<b>Office Action Summary</b>	<b>Application No.</b> 10/596,694	<b>Applicant(s)</b> D'ARRIGO, ANGELO	
	<b>Examiner</b> BRYAN P. GORDON	<b>Art Unit</b> 2837

## DETAILED ACTION

**Figure A**

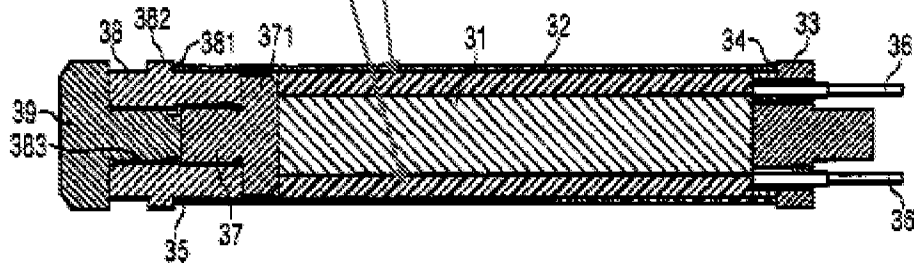
1. The drawings are objected of Figure A as shown below

Applicant never describes what that item of the device is

2. Perhaps an explanation of what the items pointed to in the Figure could help in the prosecution of the case. Corrected drawing sheets in compliance with 37 CFR 1.121(d) are required in reply to the Office action to avoid abandonment of the application. Any amended replacement drawing sheet should include all of the figures appearing on the immediate prior version of the sheet, even if only one figure is being amended. The figure or figure number of an amended drawing should not be labeled as "amended." If a drawing figure is to be canceled, the appropriate figure must be removed from the replacement sheet, and where necessary, the remaining figures must be renumbered and appropriate changes made to the brief description of the several views of the drawings for consistency. Additional replacement sheets may be necessary to show the renumbering of the remaining figures. Each drawing sheet submitted after

**Figure B**

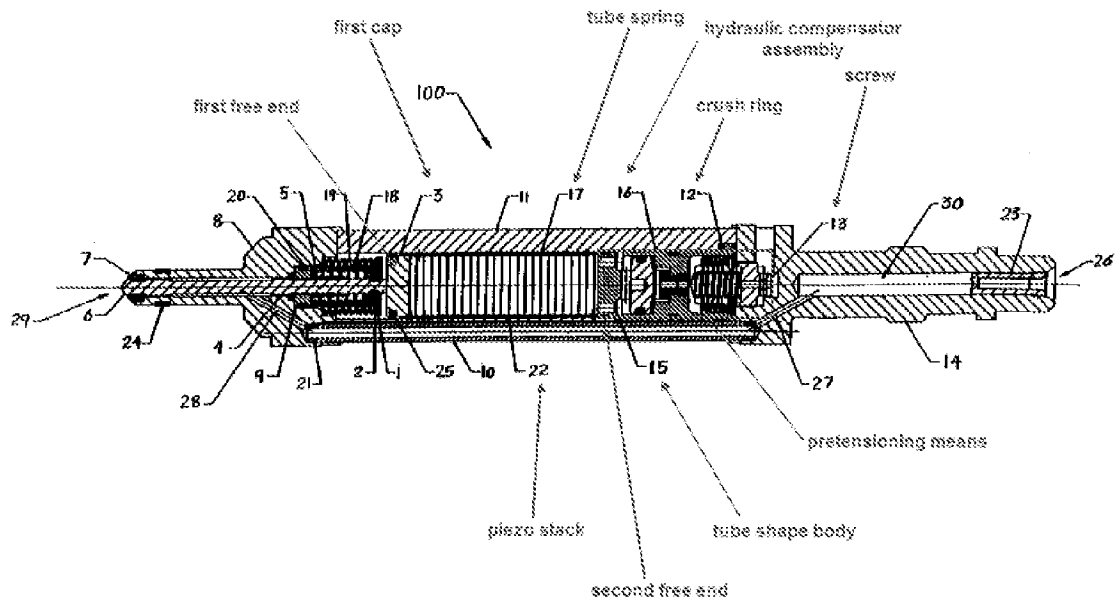
9. Considering claim 1, Shen (Figure B) teaches a piezoelectric actuator unit comprising: a tube spring (17); a piezoelectric actuator (22), that is inserted into the tube spring, a first cap (3), that is connected to the tube spring at a first free end (See Figure A above) of the tube spring and which is adjoined by the piezoelectric actuator (22), a tube-shaped body (15) that is connected to the tube spring by joining and is arranged in the area of a second free end (see Figure A), and a means for pretensioning the piezoelectric actuator after the tube spring (17) is connected to the first cap (3) and the tube-shaped body (15) (col. 3 lines 7-15, the device is already together therefore all the parts are connected) the means for pretensioning being supported by the tube-shaped body (col. 5 lines 52-54), and pretensions the piezoelectric actuator (col. 5 lines 49-57) by physically compressing the piezoelectric actuator (22) but not the tube spring.

10. Considering claims 4 and 13, Shen (Figure B) teaches a thread in the tube-shaped body and wherein the pretensioning means is a screw (13) that is screwed into the thread.

11. Considering claim 10, Shen (Figures B) Shen (Figure B) teaches a piezoelectric actuator unit comprising: a tube spring (17); a piezoelectric actuator (22), that is inserted into the tube spring, a first cap (3), that is connected to the tube spring at a first free end (See Figure A above) of the tube spring and which is adjoined by the piezoelectric actuator (22), a tube-shaped body (15) that is connected to the tube spring by joining and is arranged in the area of a second free end (see Figure A), and a means for pretensioning the piezoelectric actuator after the tube spring (17) is connected to the

### Figure C

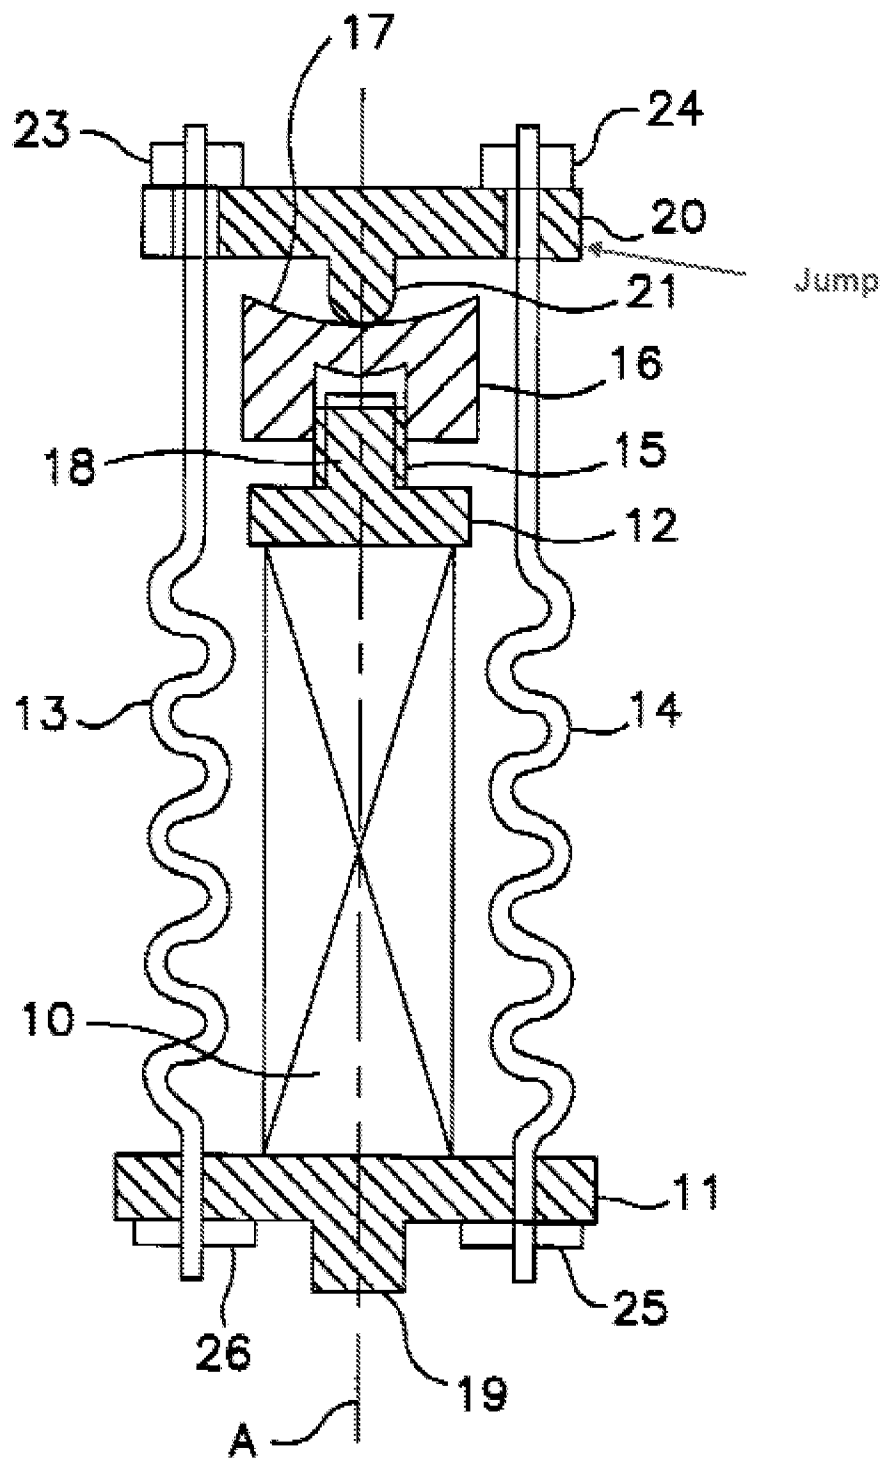
18. Considering claims 6 and 15, Mattes (Figure C) teaches the tube-shape body has a jump in its diameter on its outer circumference.
